MEMORANDUM

SUBJECT: Plan Review

■ **SOUTH FRONT APARTMENTS (NESBITT REDEVELOPMENT)**
File No. 20110005 – Second Review plans received 03.10.11

CITY OF WILMINGTON SIGHT DISTANCE TRIANGLES

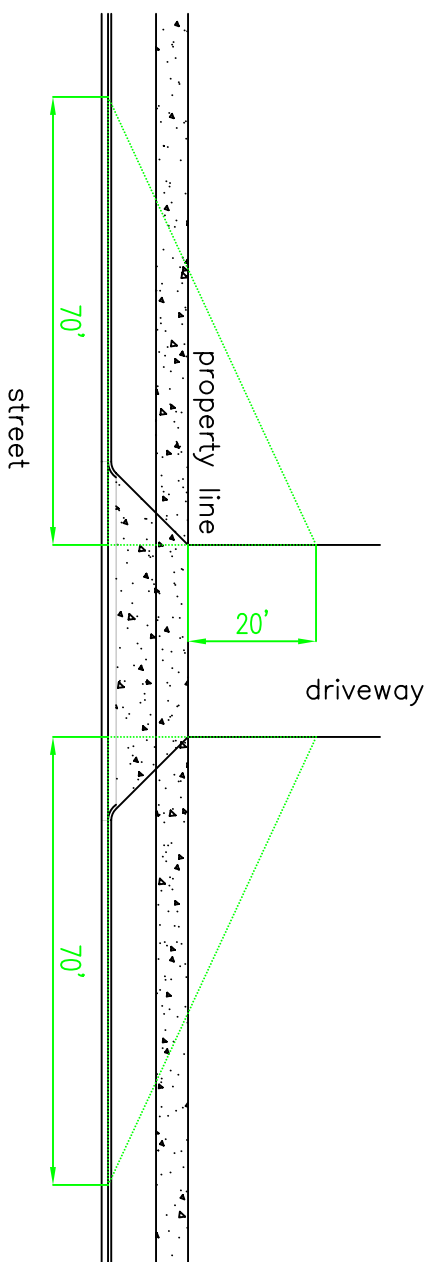
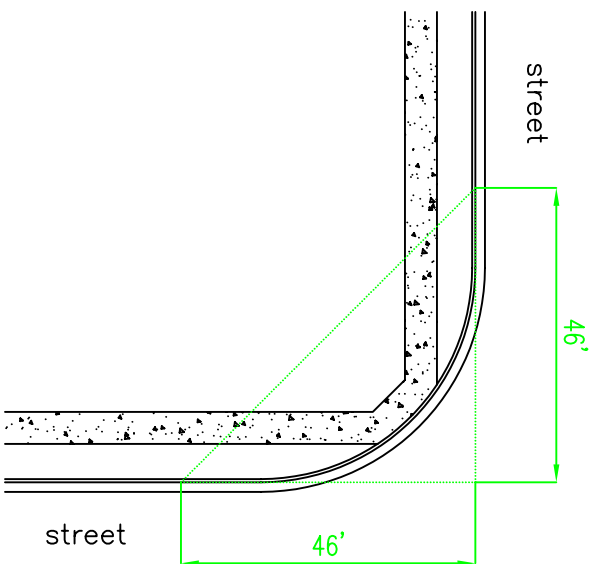
9. Sight distance triangles have not been shown correctly. Please refer to the attached illustrative and revise the plans accordingly.
10. Transportation Planning Staff will review the landscape plan once submitted for compliance with sight distance requirements.
11. Transportation Planning Staff reserves the right to review and comment on any additional plans submitted for this development.
